Project title	Gasworks Weir Fish Pass	Job number	273427
cc		File reference	273427 - ARP - XX - XX - FN - XX - 1012
Prepared by	Holly Webster	Date	31 July 2020
Subject	Fish pass design updates

Ove Arup & Partners Limited (Arup) has been commissioned by Natural Resources Wales (NRW) to support the development of a fish/eel pass within an existing weir ('Gas Works weir') on the River Ebbw.

The weir is an approximately 1m high and located on the Ebbw Fach river a tributary of the River Usk in Wales. The weir poses and obstruction to migratory fish and prevents access to circa 3km of potential spawning ground for salmon. The proposals aim to meet current fish pass standards with a focus on salmonids. Arup were appointed to update the consents and finalise the construction work information from a 2014 design by Halcrow. This note details design changes to the 2014 design.

Figure 3: Extract from the Halcrow's general arrangement drawing

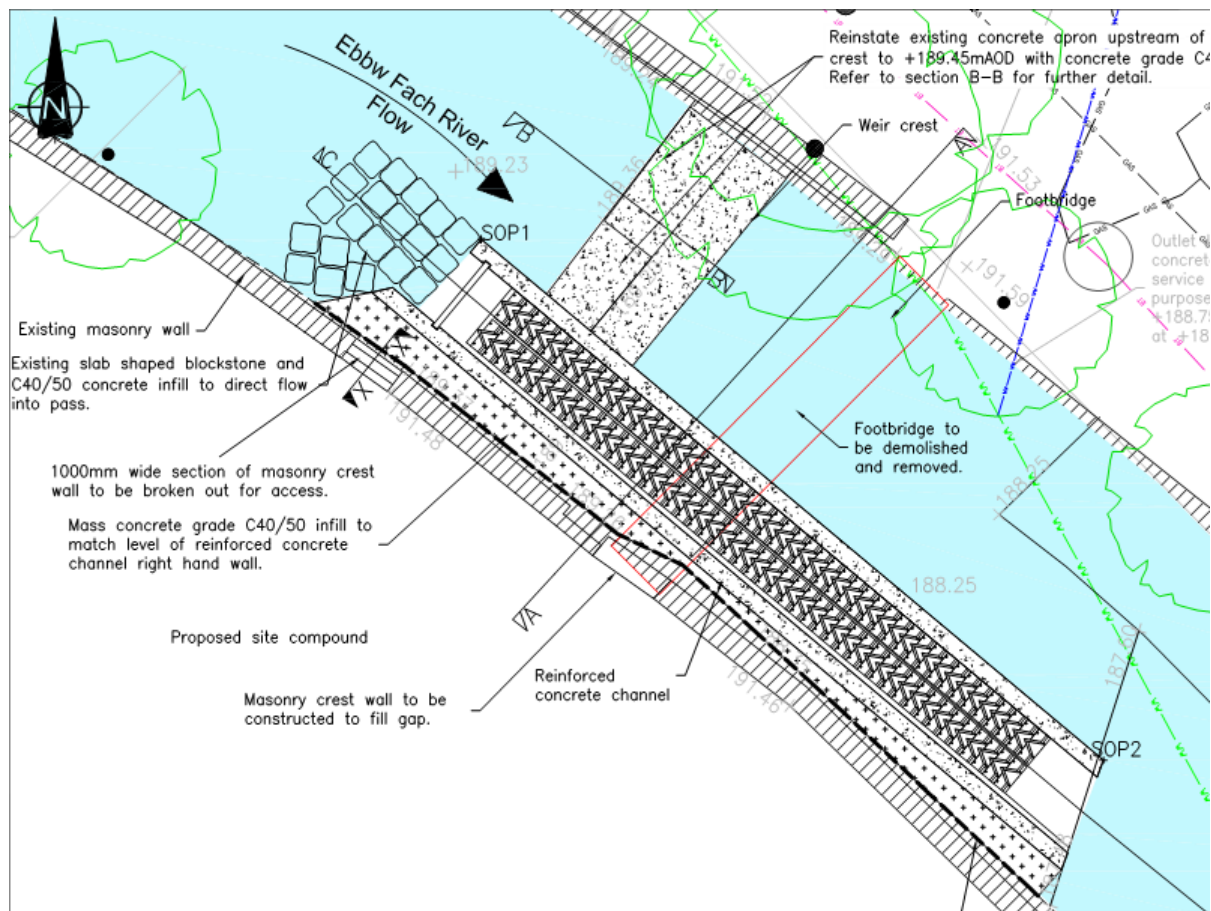
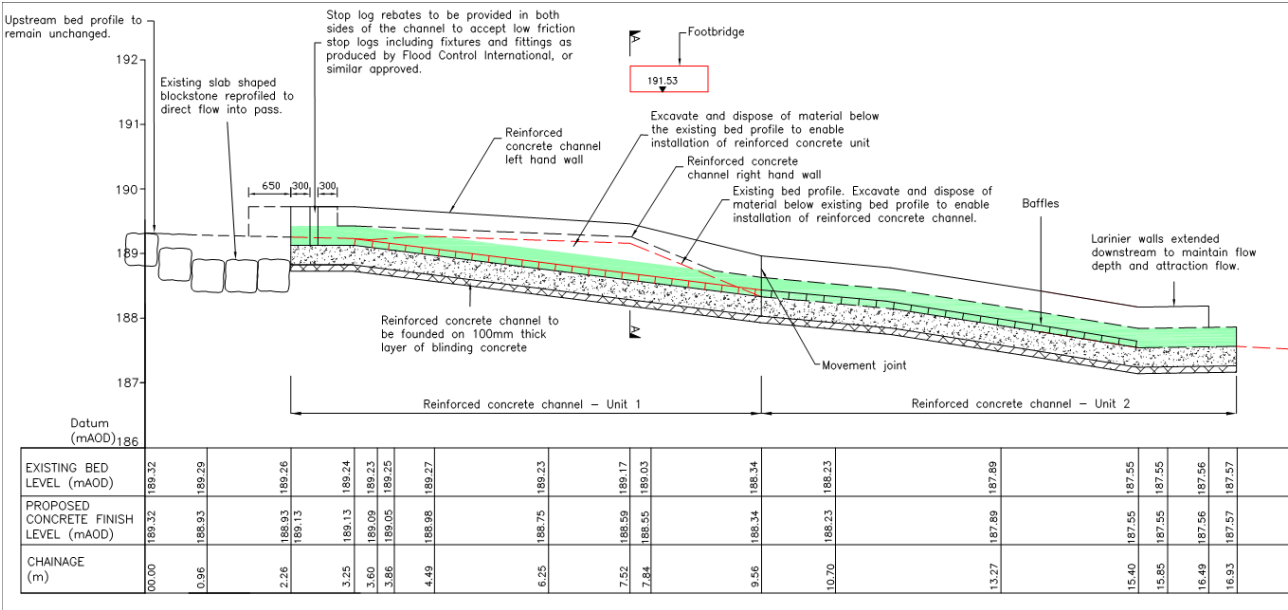
- Issue 1: The current design does not operate until flows >Q84. This is not best-practice. The Larinier should function at least at flows as low as Q95.

- Issue 2: The Larinier has multiple slope gradients. This is not best-practice and will not be approved by the FPP without sufficient evidence of its functionality.

- Issue 3: The side walls of the proposed design will allow over-topping at relatively common flows- affecting Larinier performance.

- Issue 4: There is no downslope to bed at the upstream end of the Larinier

- Issue 5: Lacking details on the position of stop-log slots, camera slots and US and DS water levels

- Issue 1: The 70 mm wide vertical eel passes are prone to blockage and are not best-practice.

- Issue 1: The notches do not make maximum use of the flow in order to minimise the head-drops.

- Issue 2: The pre-barrages appear to not be set flat and do not have an adherent nappe profile.

Correction 1: We have re-designed to be Larinier 600 mm wide (rather than proposed 1200 mm) and lowered the invert of the upstream baffle to 189.12 m AOD to ensure operation at Q95.

Correction 2: We have re-designed the Larinier to be a single slope (15 degrees) with 100 mm baffle height.

Correction 3: We have designed the side-walls to be sufficient to contain Q10 water levels plus 100 mm.

Correction 4: We have added a 1-in-2 slope to bed at the upstream end of the Larinier and indicated that this can be the site for mounting a white flashboard for future camera monitoring.

Correction 5: We have added these details to the design.

Correction 1. We have designed a new 500 mm wide gravity-fed eel pass which is sited bankside of the Larinier in a reinforced concrete channel. The eel tiles within this concrete channel have a lateral slope that ensures operation over the recommended hydrological flow range of Q99-Q70. The eel pass has a downslope to bed at the upstream and downstream end.

Correction 1: The notches have been re-designed (deeper) and re-positioned to reduce head drops between them.

Correction 2: The pre-barrages have been designed to be flat with adherent nappe profile to promote streaming flow and minimise risk of injury.

Figure 5: General Arrangement as per FishTek updates

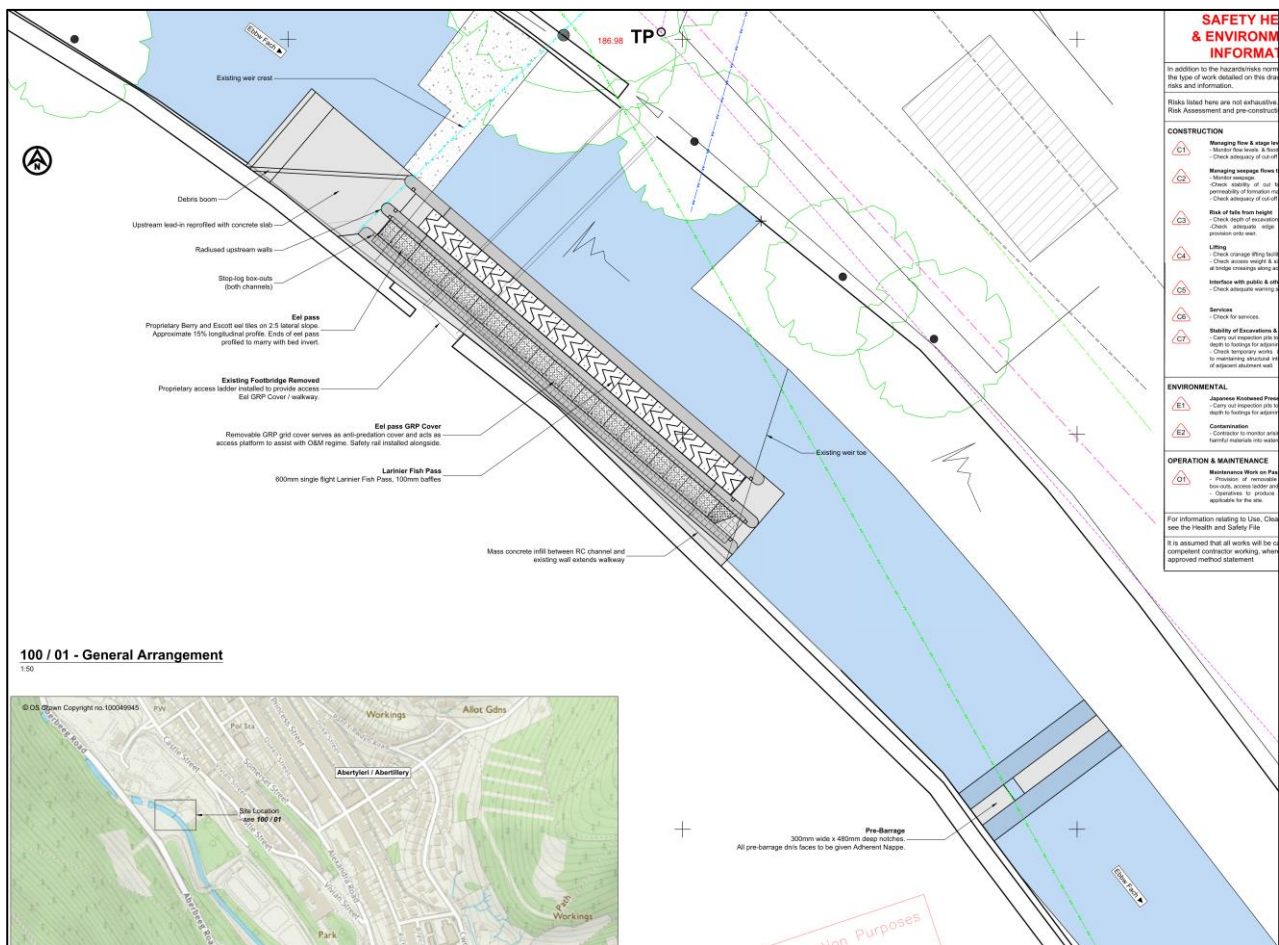
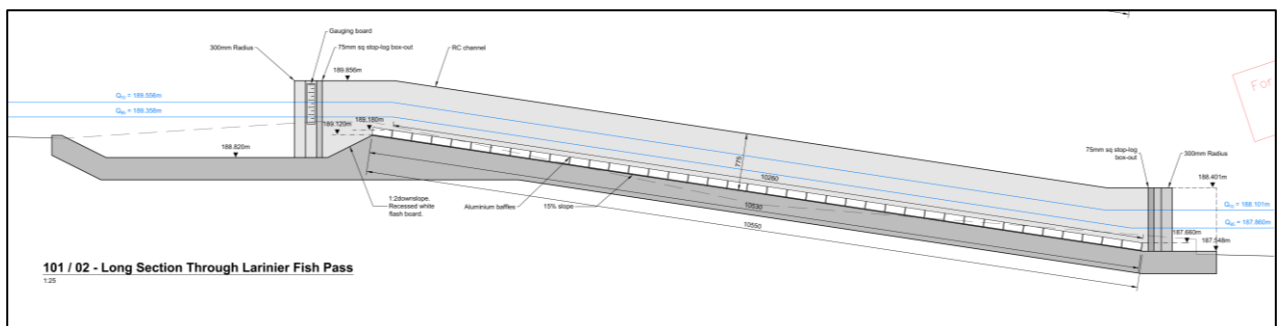
- *GRP cover/walkway over the eel pass. Remove this from the design. It will catch debris in flood events causing blockages and potential to get damaged by debris. Not required.*
- *Safety rail alongside GRP cover– remove from design. Potential debris catcher. Not required.*
- *Ladder onto fish pass. Remove from design. Not required. Potential to catch debris and get damaged. Fish pass can be visually inspected from above and if safe, access for maintenance will be via existing ramp access into the river 50m upstream of the weir.*
- *Upstream debris boom. Their use in similar Valleys rivers has created more debris maintenance issues than they alleviate. Remove from design. Not required.*

Given the above information, the design is likely to need adjusting and the weir appropriately lowered at the fish pass entrance. The current intention to lower by 18cm (as stated in form-wra) would only ensure flows <Q99.

(1) the whole Larinier design is lowered by 0.15 m.

(2) the whole eel pass design is lowered by 0.10 m.

(3) Pre-barrage 1 (closest to the Larinier toe) is lowered so the crest is at 187.71 m AOD and the notch is widened from 0.3 m to 0.42 m.

(4) Pre-barrage 2 (most downstream pre-barrage) is lowered so the crest is at 187.47 m AOD and the notch is widened from 0.3 m to 0.42 m.
